RAILWAYS AND PUBLIC WORKS:

REPORT OF THE ROYAL COMMISSION.

ROYAL COMMISSION
ON
RAILWAYS AND PUBLIC WORKS.

REPORT
OF
THE COMMISSIONERS,

BRIDGE Nº1, OVER RIVER DERWENT.

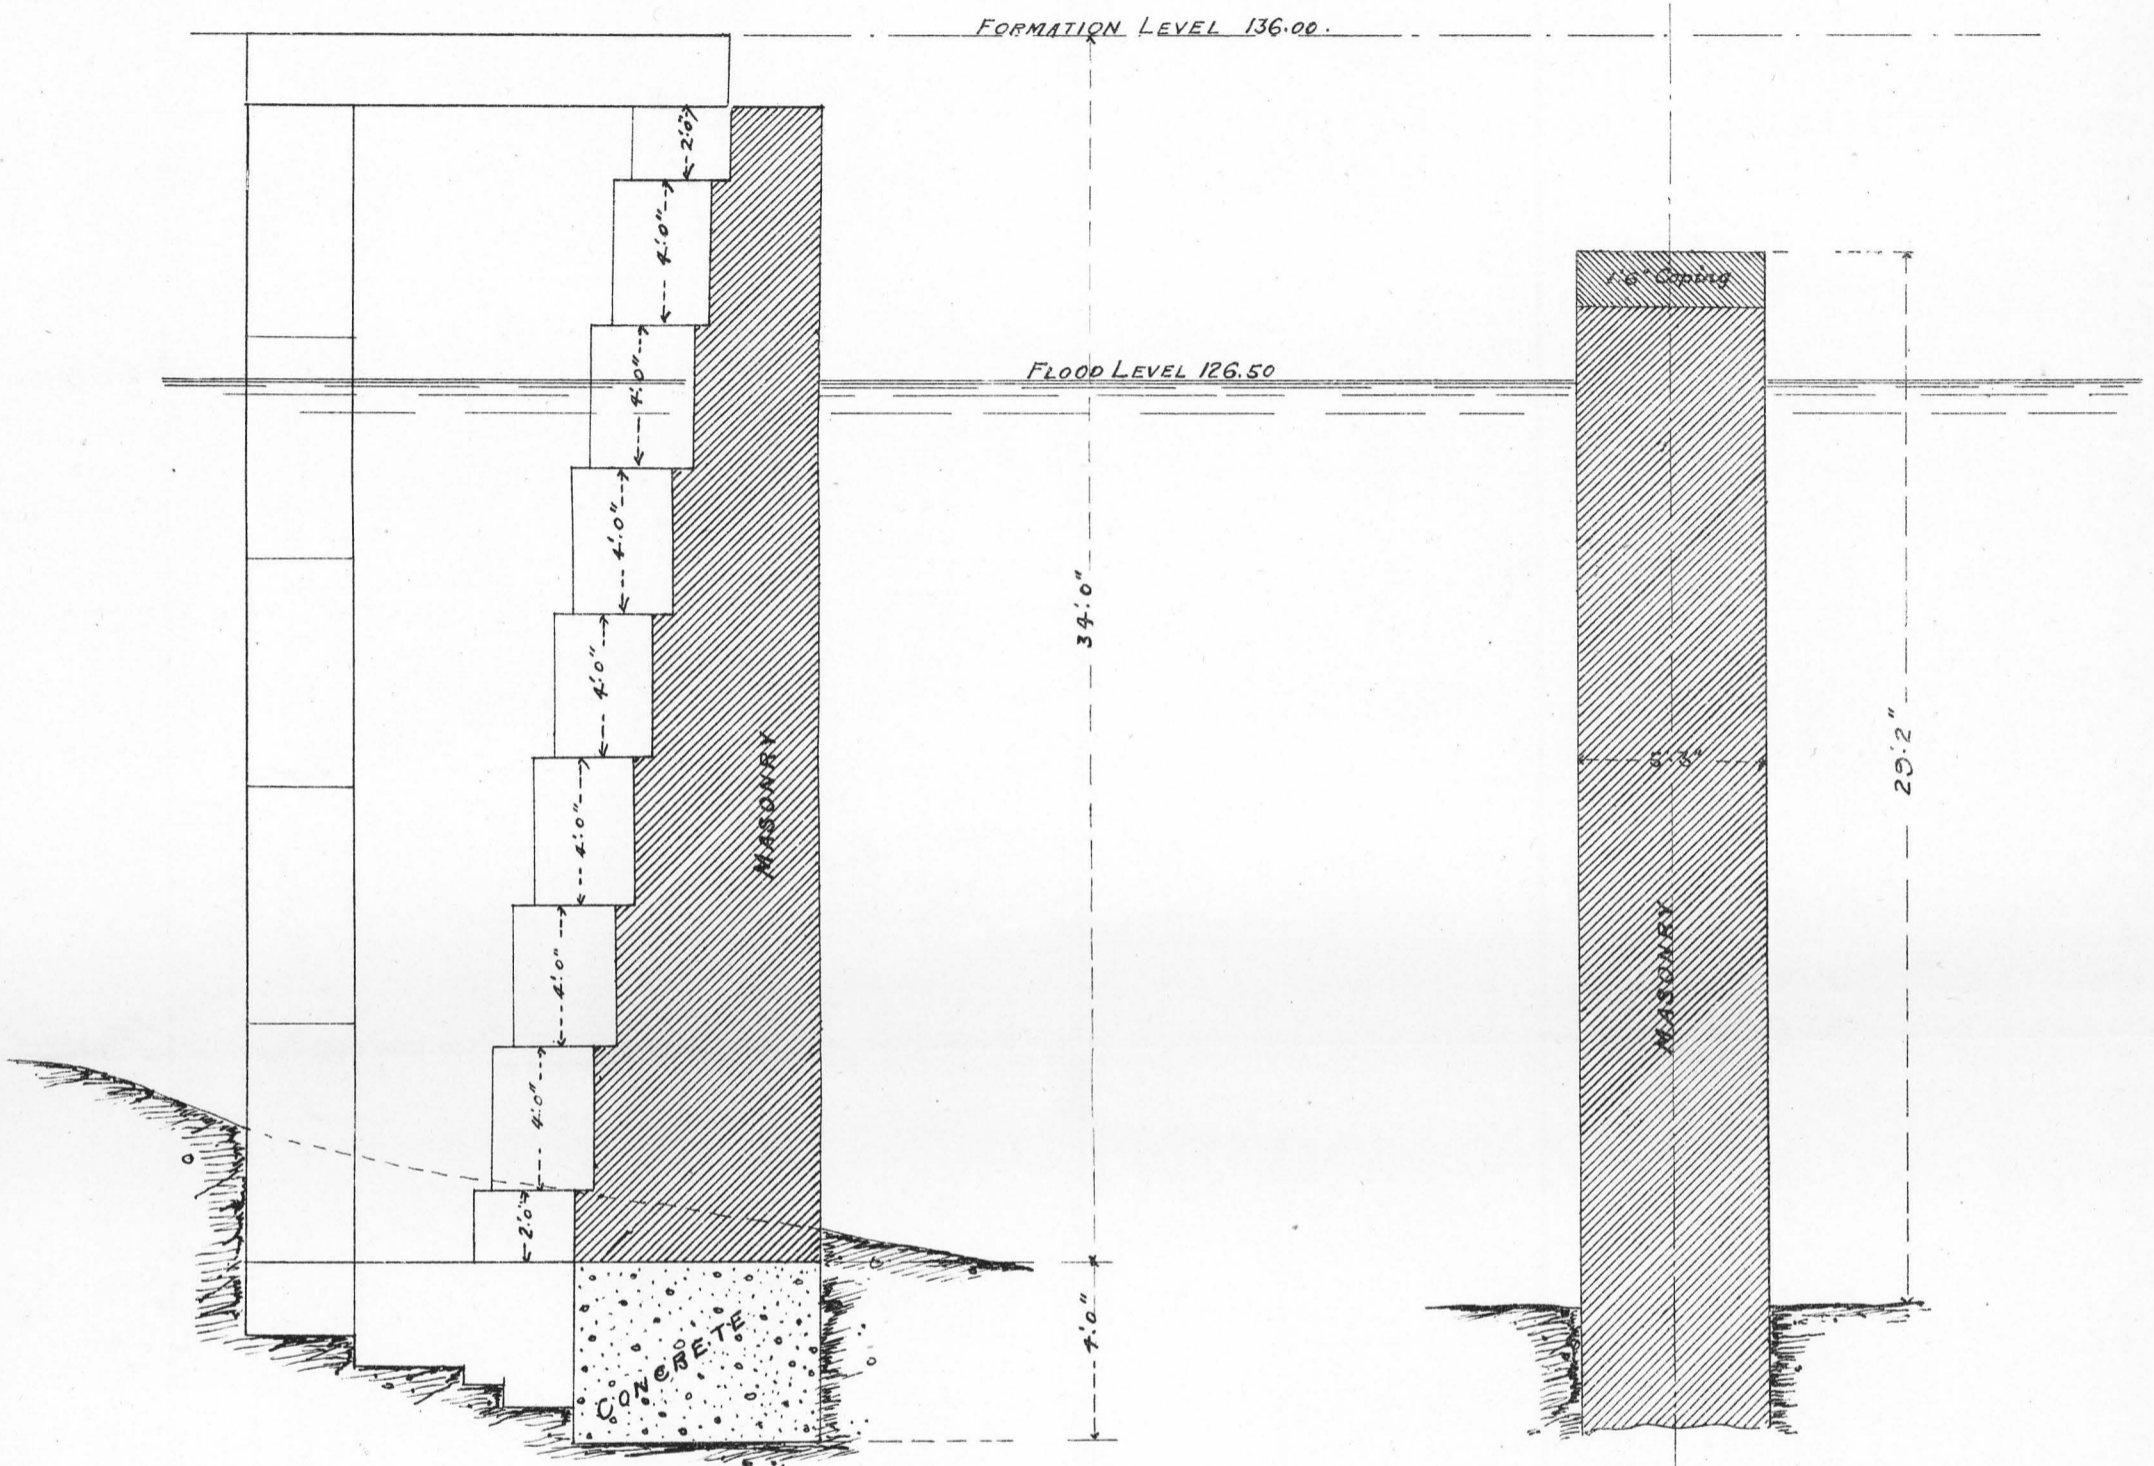
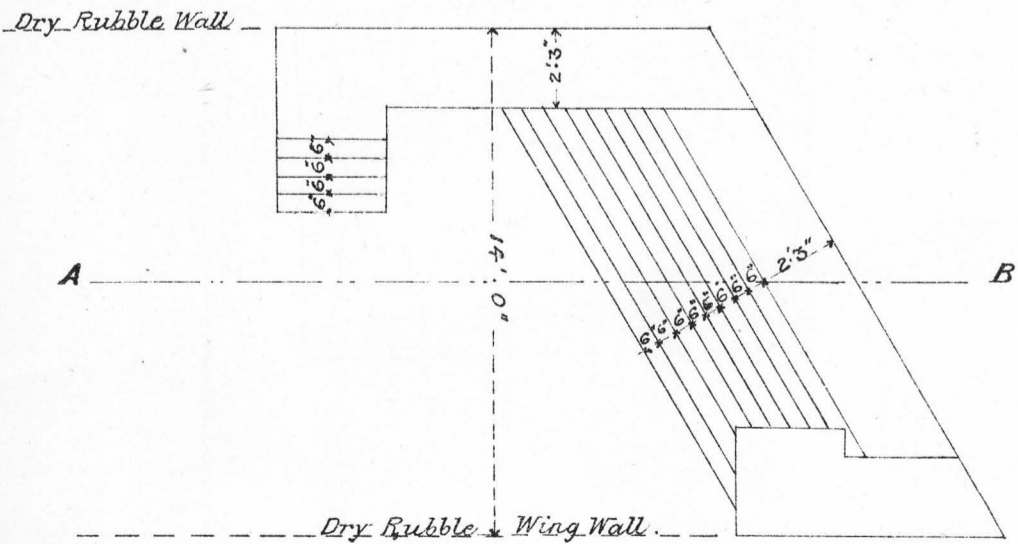
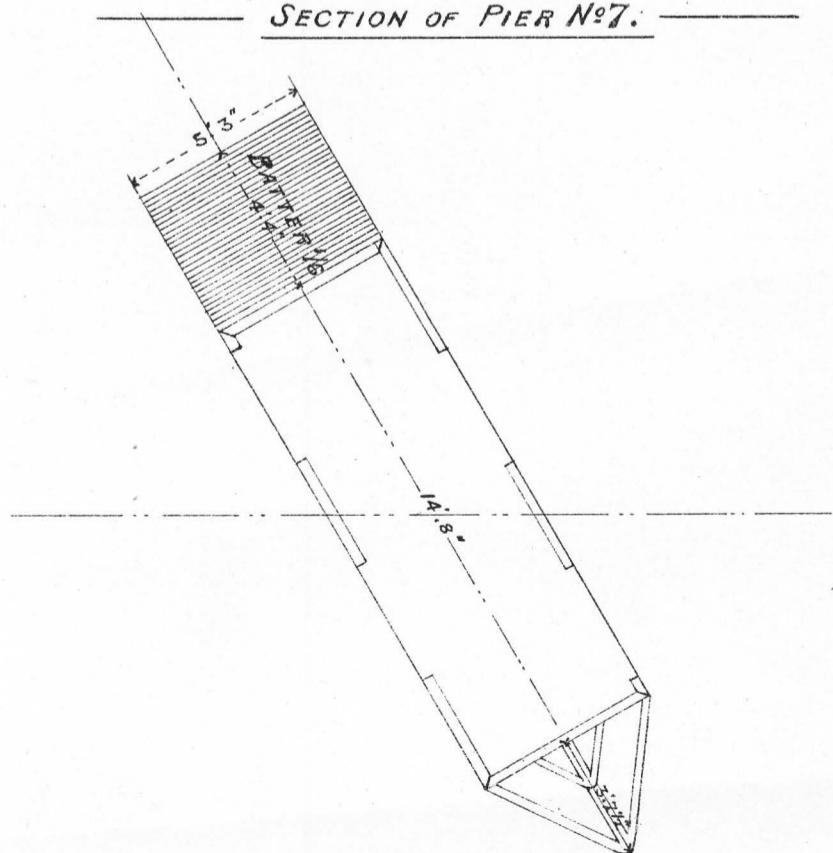
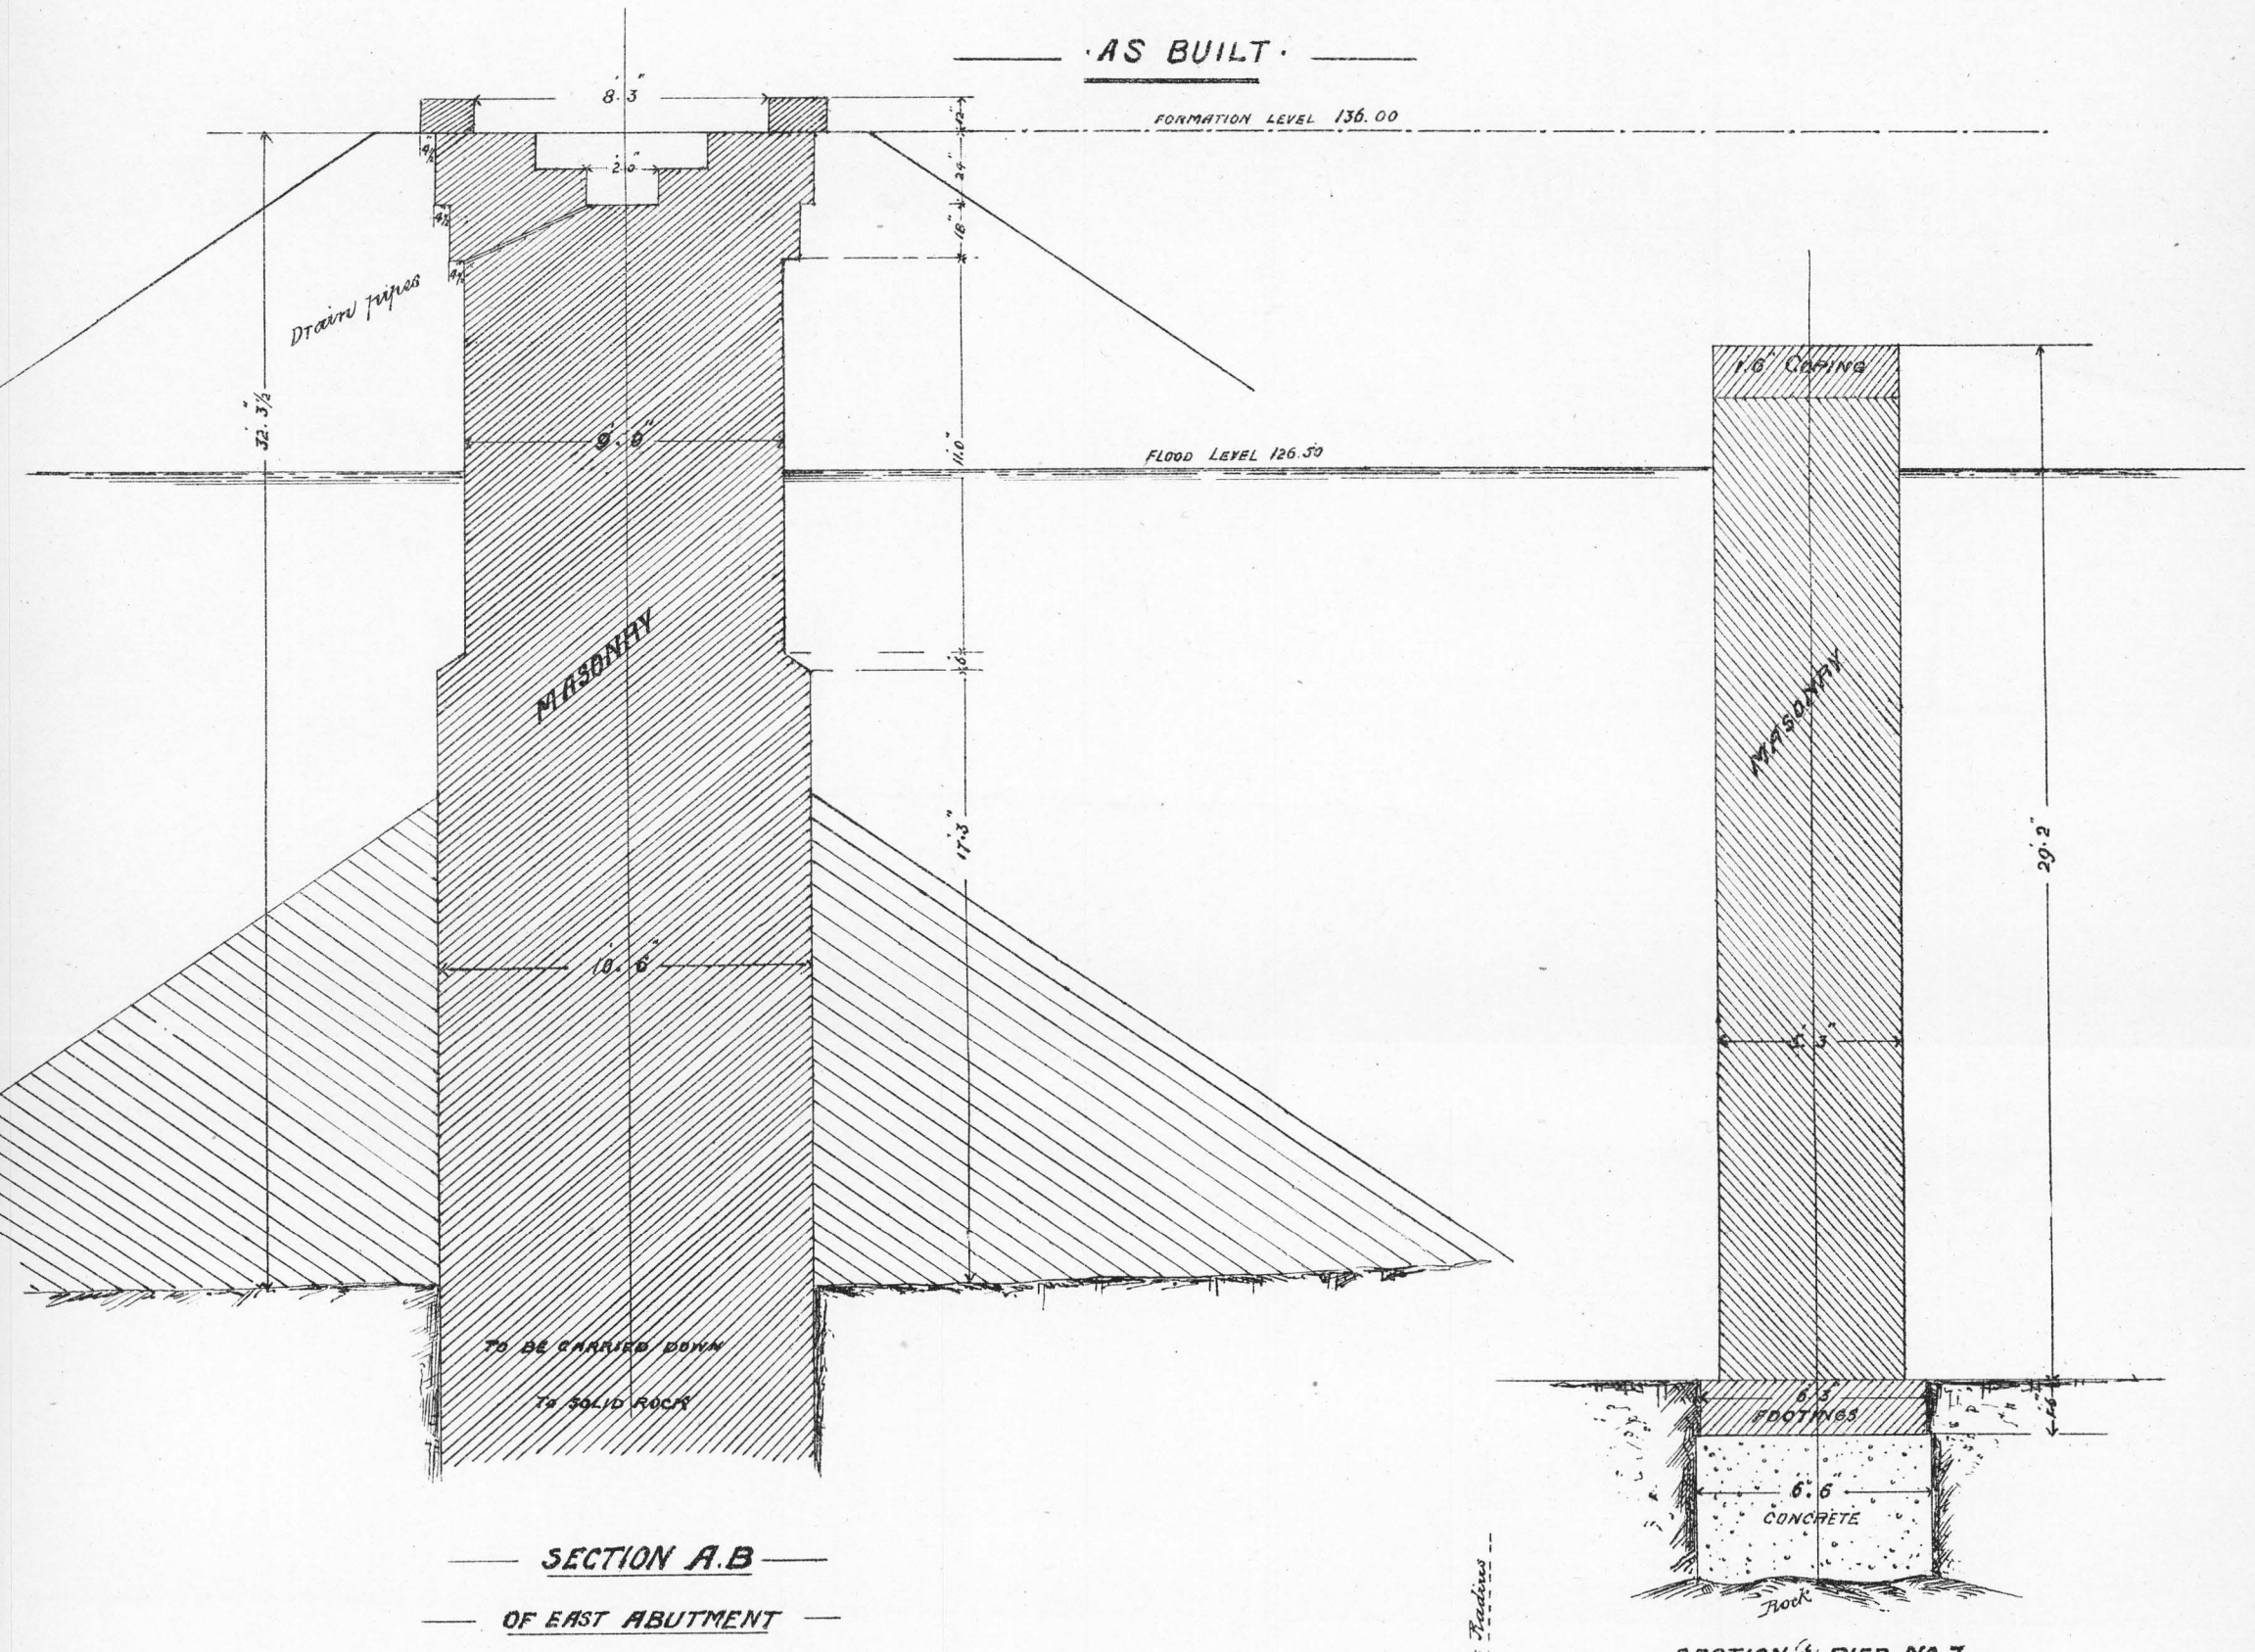
The design of the girders show them to be strong enough, and calculated to do more than can be required of them; but the manner in which it is proposed to fix them on the masonry; the small distance they are spaced apart, making their base only equal to their height; the want of strong external stays to the girders on the piers; the absence of diagonal bracing to the upper members of the girders; and the neglect to provide any means of fastening the timber floor to the upper bed-plates, constitute grave defects in the design.

We disapprove of the proposal to weaken the superstructure of Nos. 1 and 3 bridges by widening the timber-deck from 8 feet to 14 feet, which the Engineer-in-Chief (question 2161) proposes with the view of forming a combined track for road and rail traffic. This means to build a pier about 60 feet in height, and on this to fix two girders 6 feet apart, and to secure to these girders a timber floor 14 feet wide, forming a roadway with an overhang of 4 feet outside the web of the girders. Such a design would be condemned by any practical builder as deficient in the elements of stability and correct proportion.

To add to the risk of heavily laden trains safely crossing these bridges, the plan and section show that the approaches to No. 1 bridge are by descending inclines on sharp curves. In addition, therefore, to the weight of the rolling load, the girders have to resist the momentum of the train caused by the inclines and the centrifugal force brought into play by the action of the curves.
